White Mining Limited
A.C.N. 009 713 893

ASHTON COAL PROJECT

ASHTON COAL MINE PROJECT

**DESCRIPTION OF ALTERNATE MINE
LAYOUT FOR UNDERGROUND MINE
(Option 4)**

**Ashton Coal Project
Underground Mine Layout
Depth of Cover to Pikes Gully Seam**

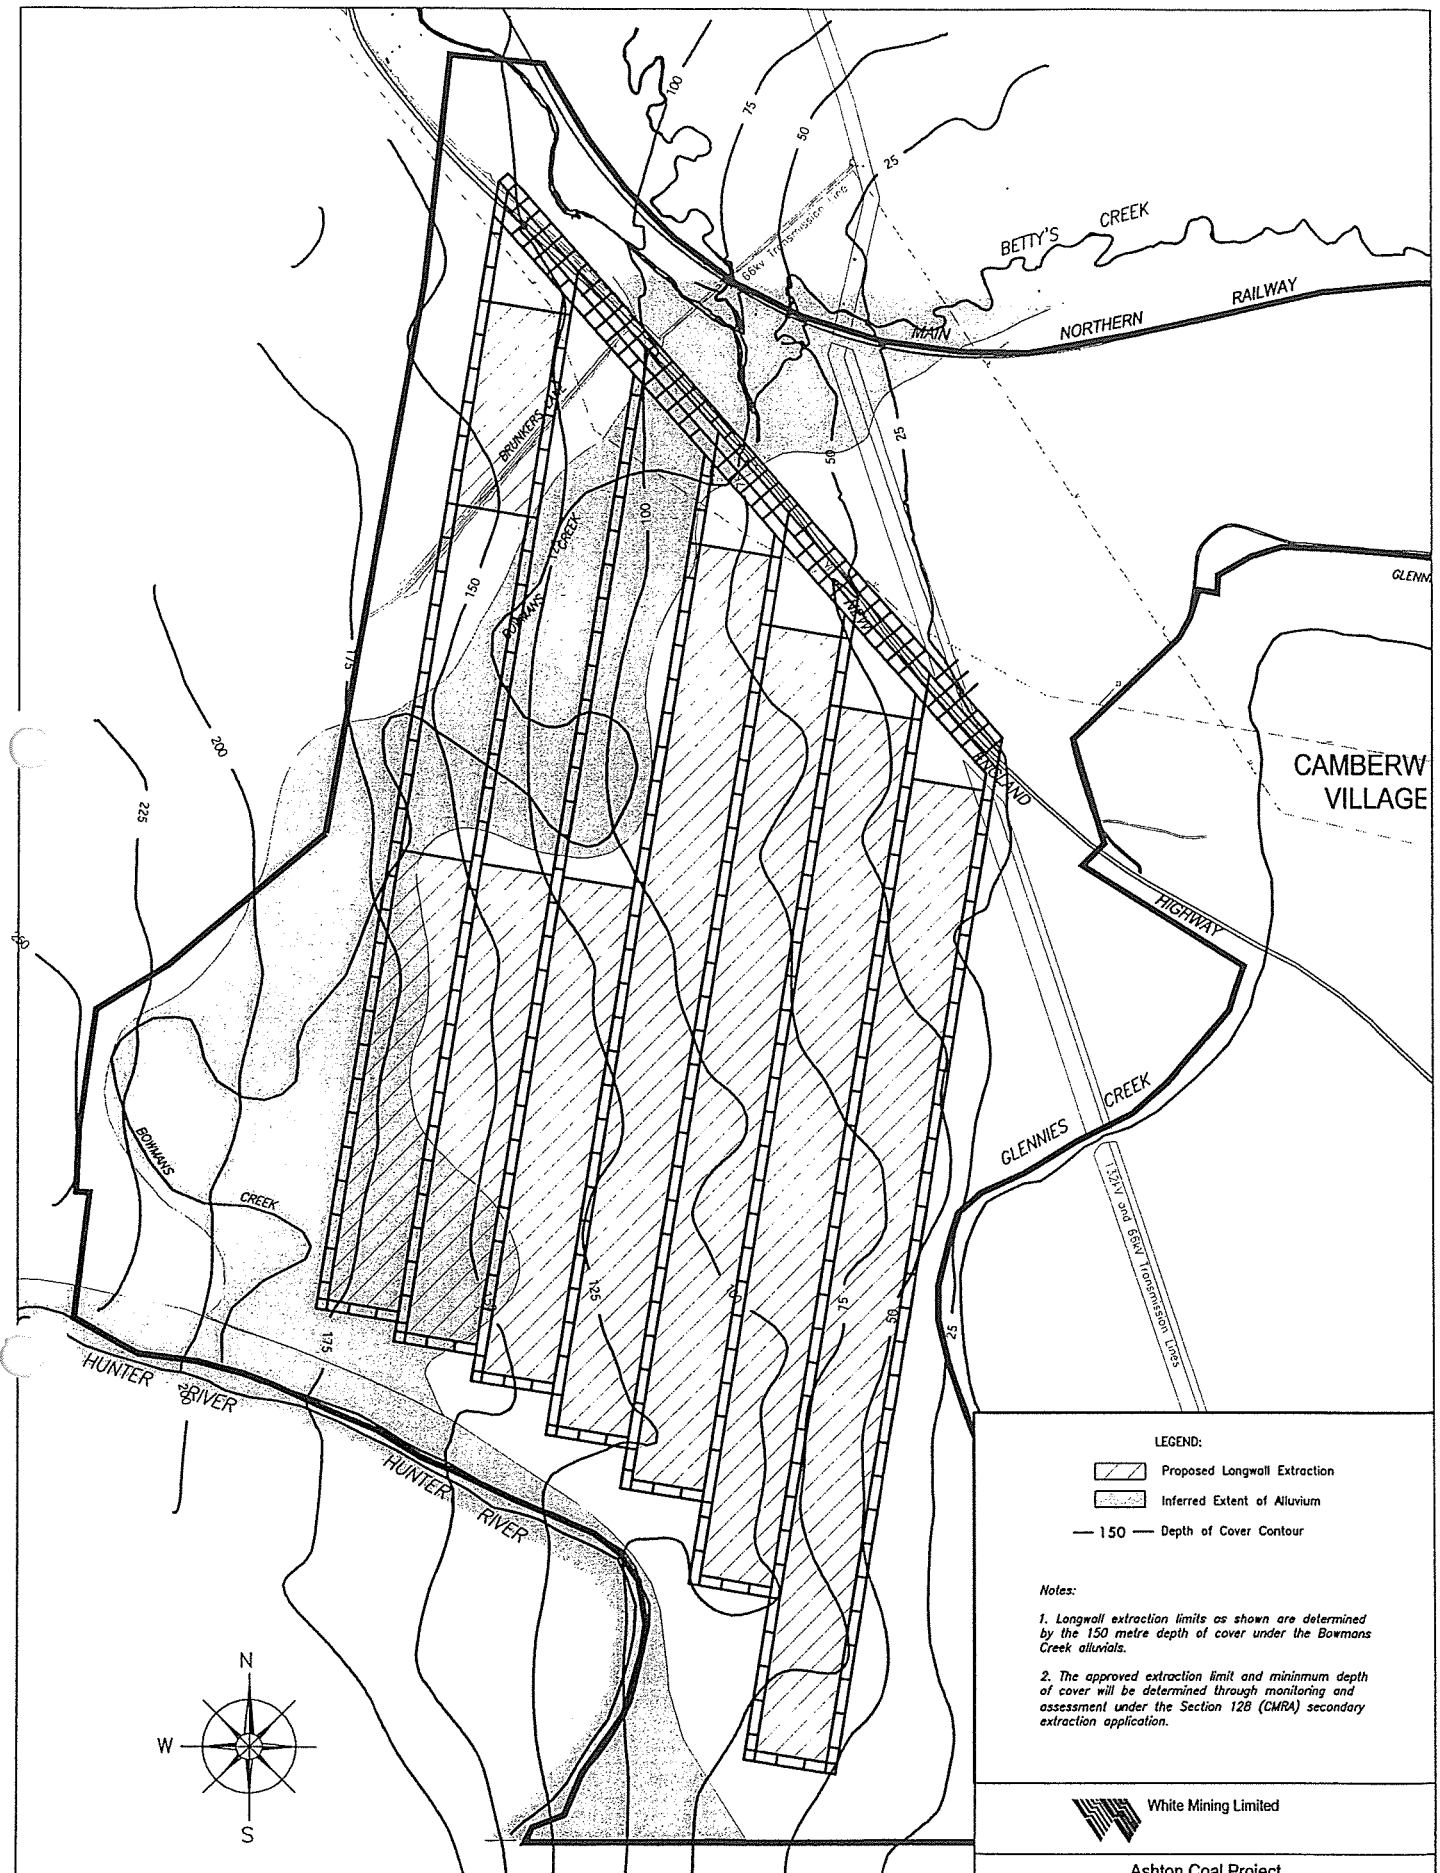
A monitoring program will be established within Longwall panels 1-3 to determine the depth of cover necessary to prevent connective cracking and the results will be incorporated in the application for secondary extraction in longwall panels 5 – 7 in accordance with Section 138 of the Coal Mines Regulation Act.

- Notes:**
1. Longwall extraction limits as shown are determined by the 150 metre depth of cover under the Bowmans Creek alluvials.
 2. The approved extraction limit and minimum depth of cover will be determined through monitoring and assessment under the Section 12B (CMRA) secondary extraction application.

**Ashton Coal Project
Underground Mine Layout
Depth of Cover to Upper Liddell Seam**

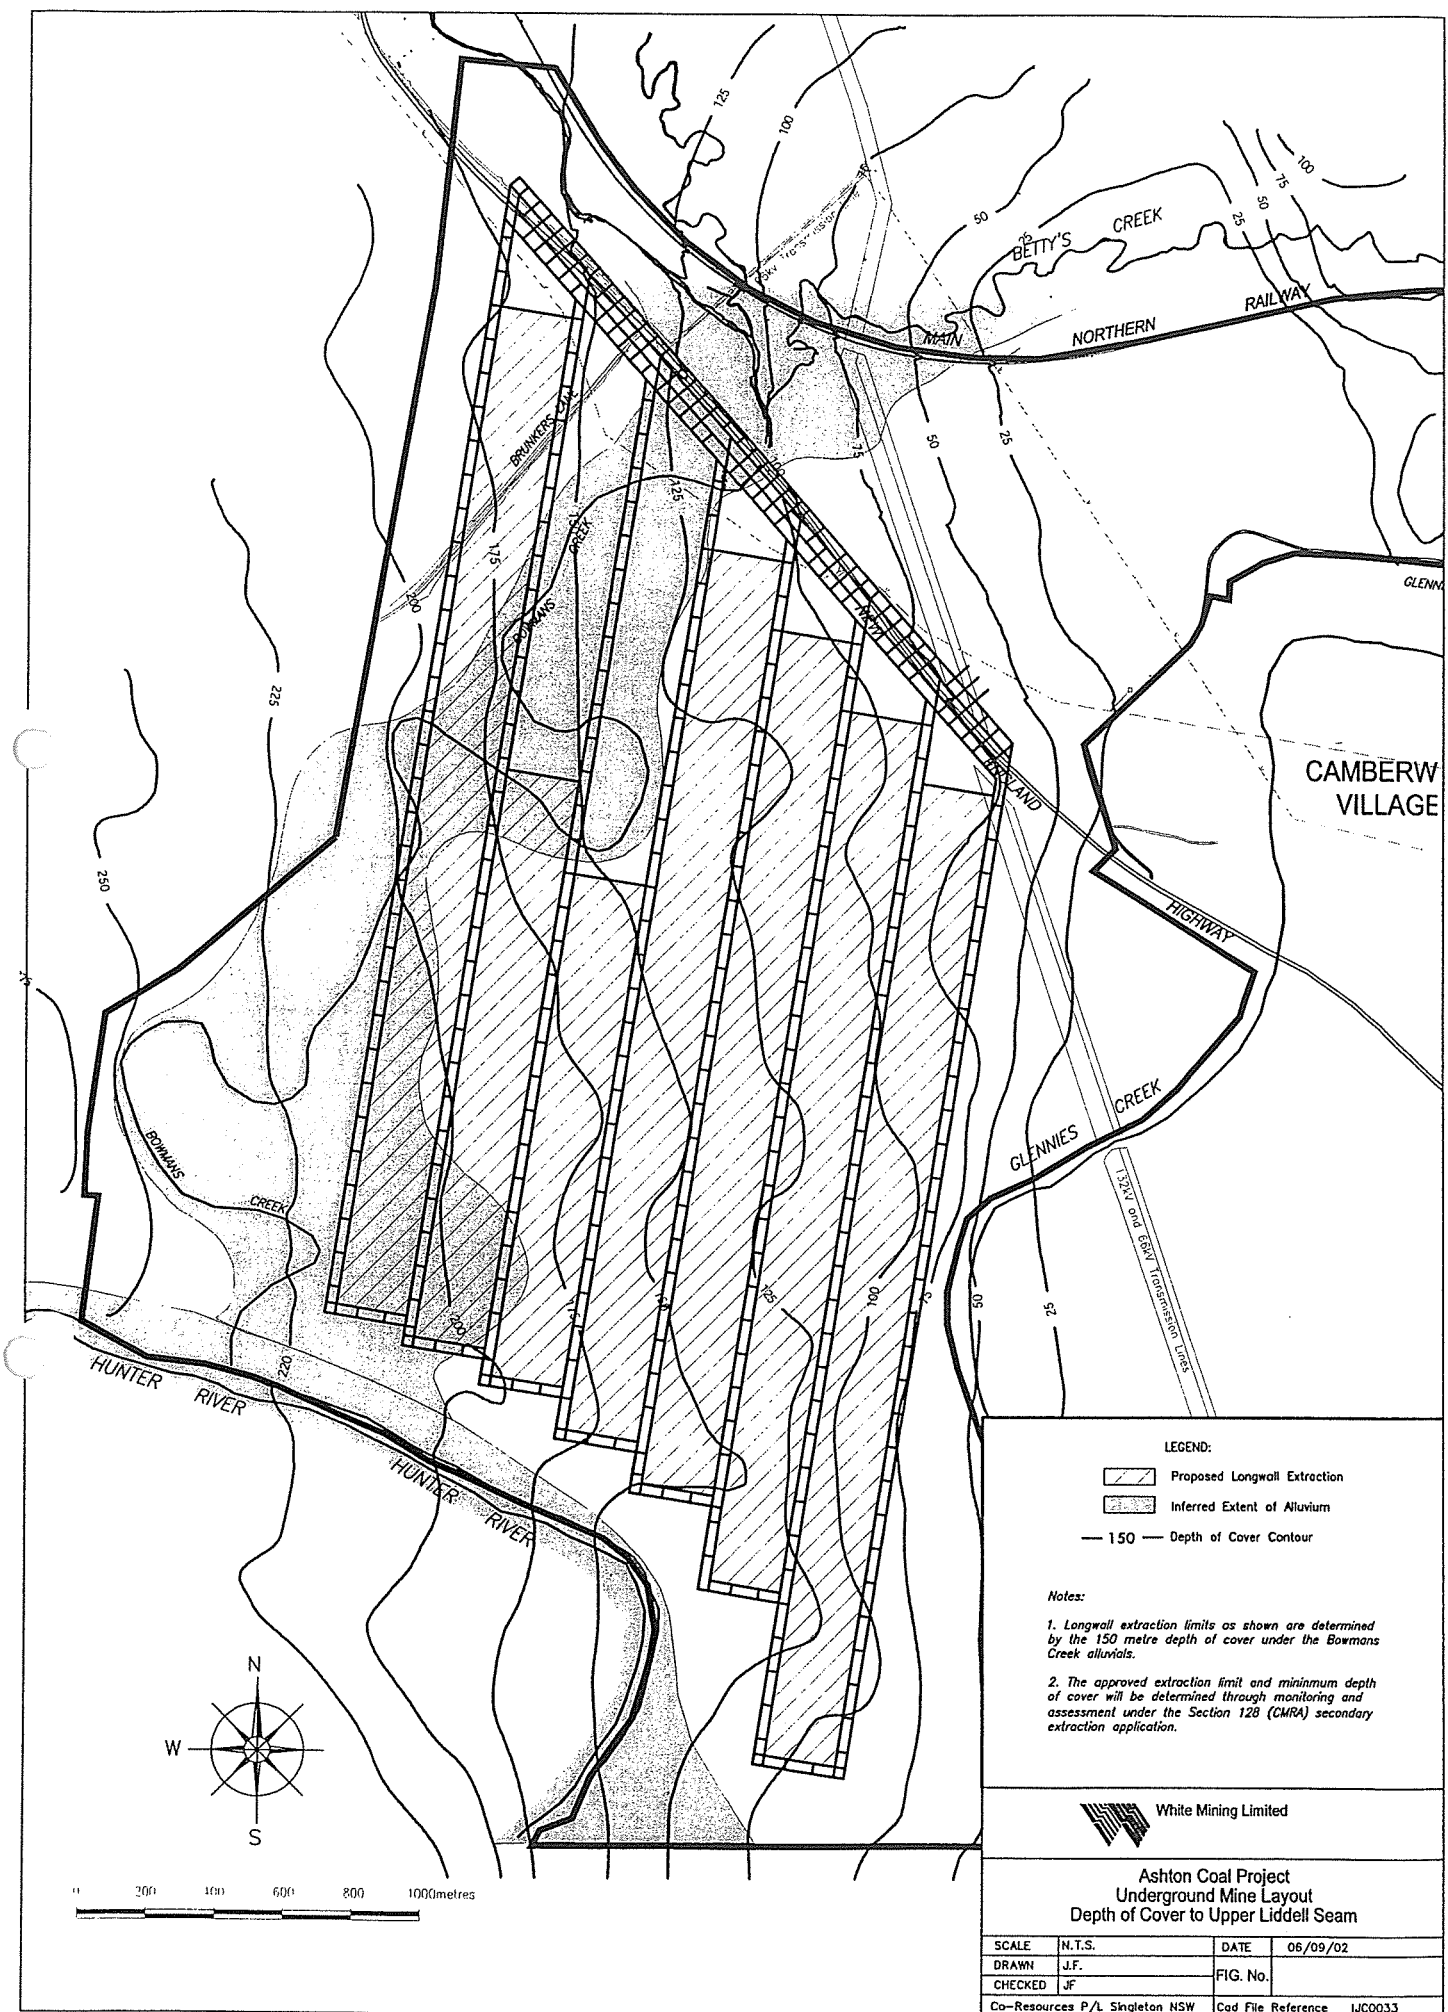
1. Longwall extraction limits as shown are determined by the 150 metre depth of cover under the Bowmans Creek alluvials.
2. The approved extraction limit and minimum depth of cover will be determined through monitoring and assessment under the Section 128 (CMRA) secondary extraction application.

**Ashton Coal Project
Underground Mine Layout
Depth of Cover to Upper Lower Liddell Seam**

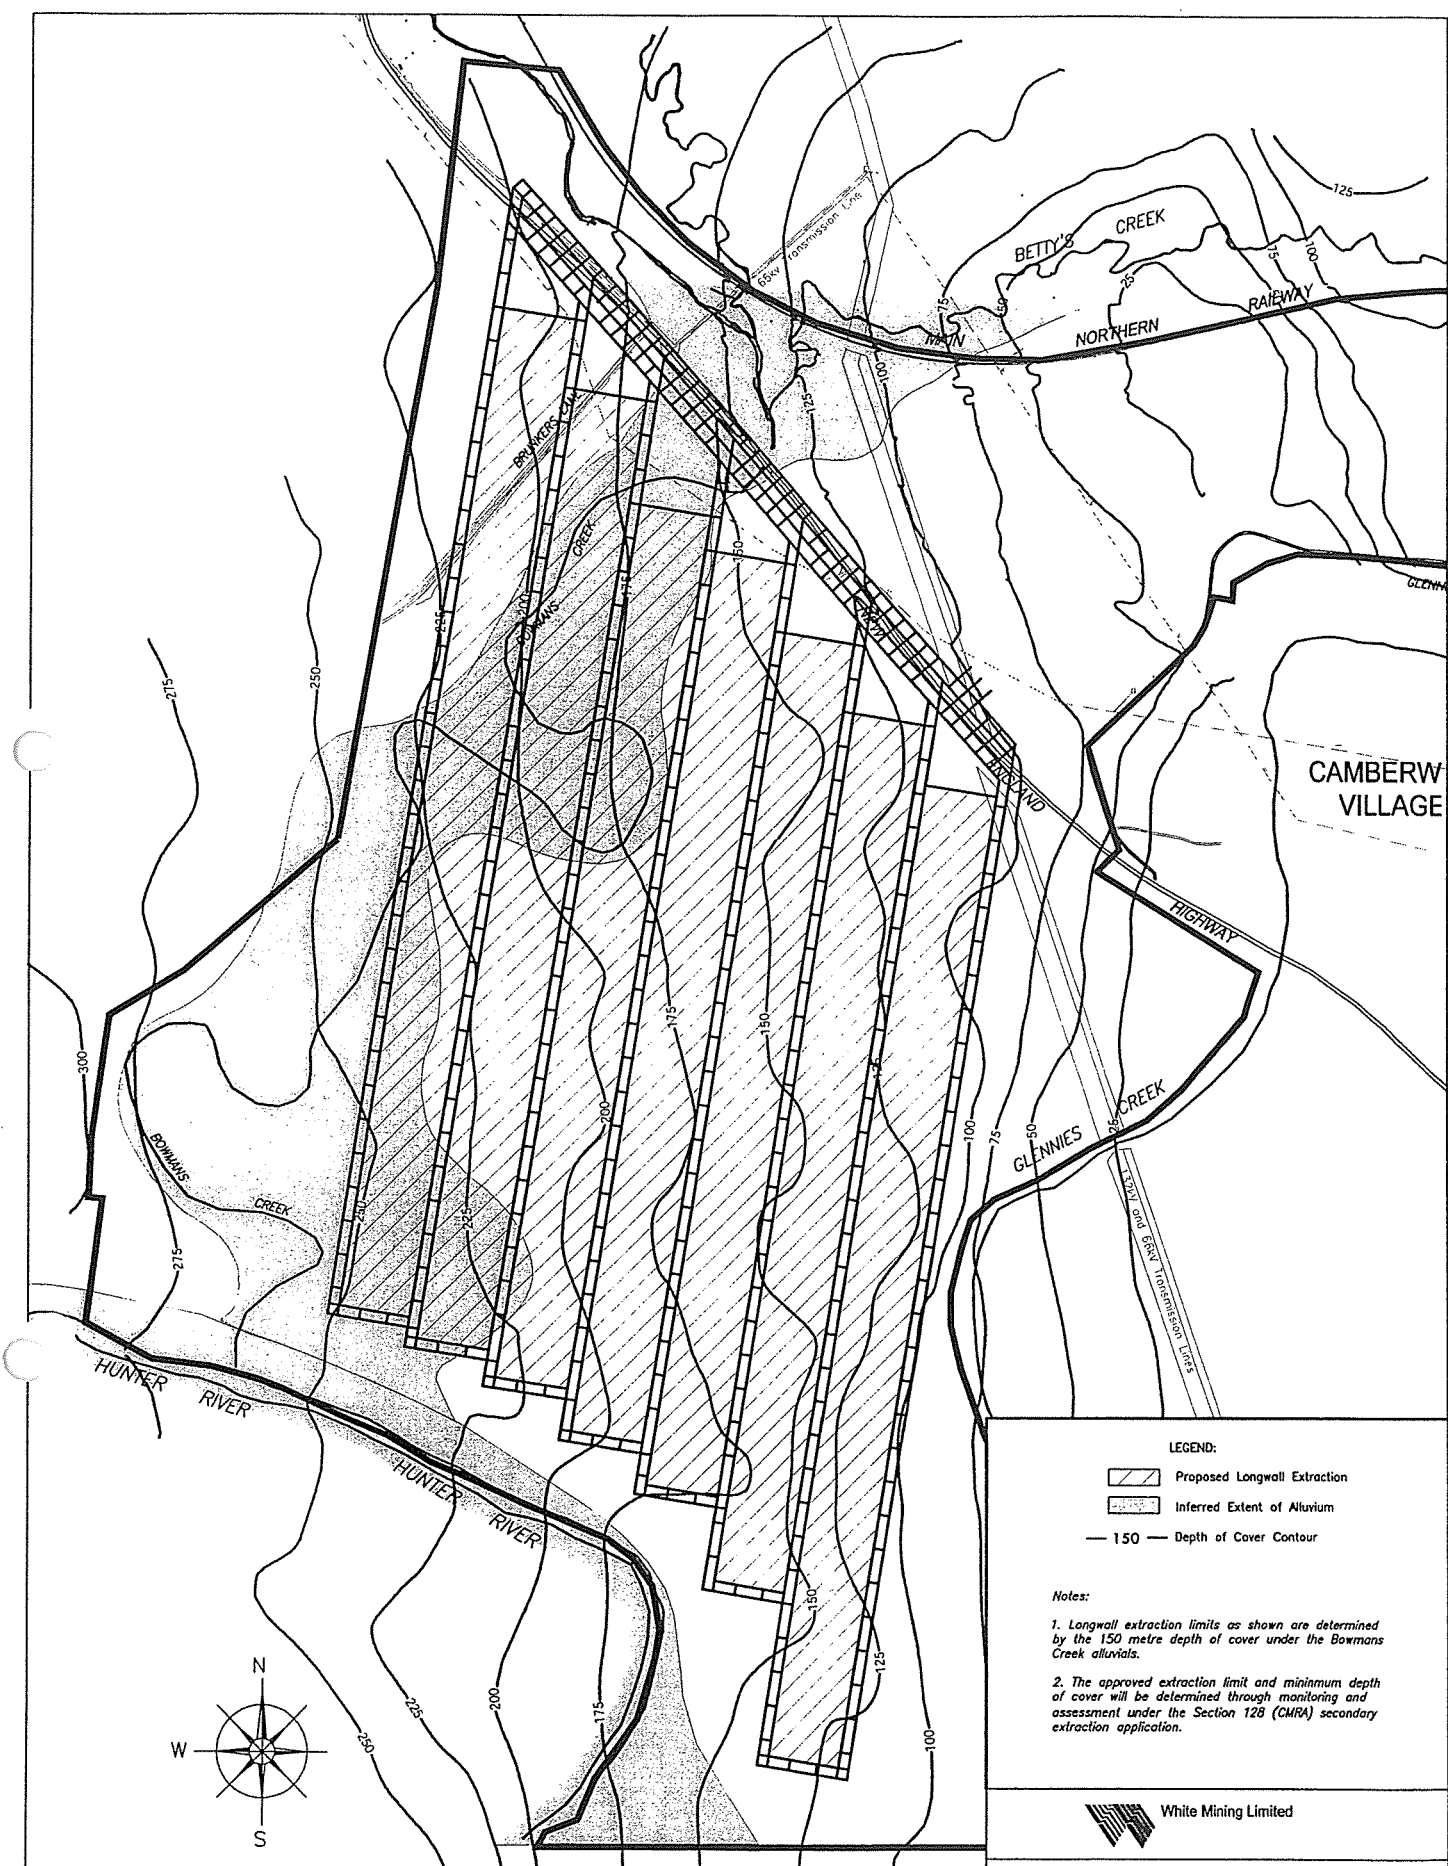
1. Longwall extraction limits as shown are determined by the 150 metre depth of cover under the Bowmans Creek alluvials.
2. The approved extraction limit and minimum depth of cover will be determined through monitoring and assessment under the Section 128 (CMRA) secondary extraction application.

**Ashton Coal Project
Underground Mine Layout
Depth of Cover to Lower Barrett Seam**

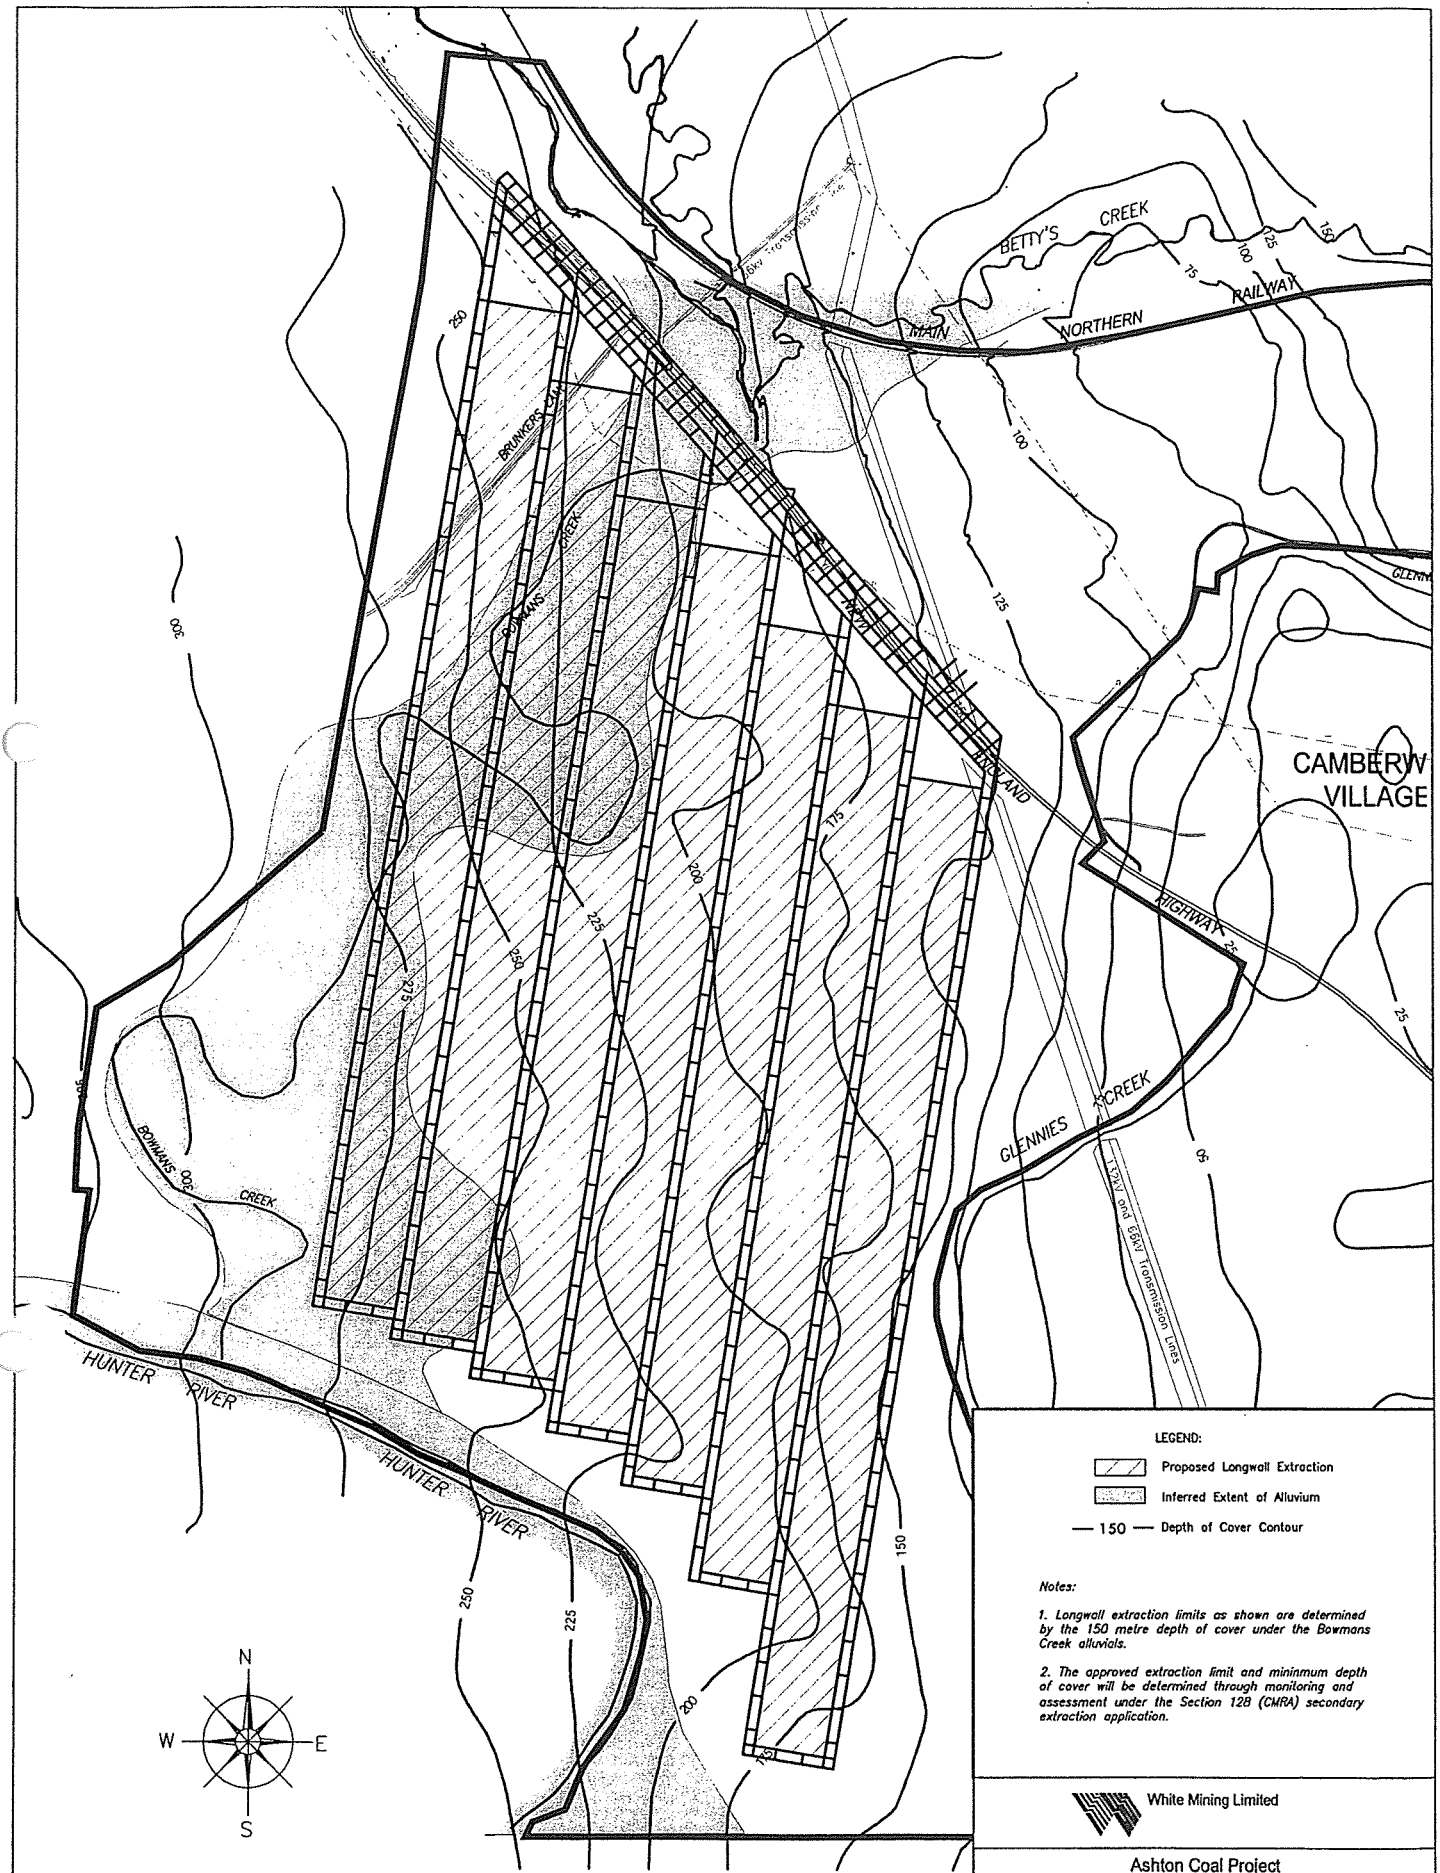
1. Longwall extraction limits as shown are determined by the 150 metre depth of cover under the Bowmans Creek alluvials.
2. The approved extraction limit and minimum depth of cover will be determined through monitoring and assessment under the Section 12B (CMRA) secondary extraction application.
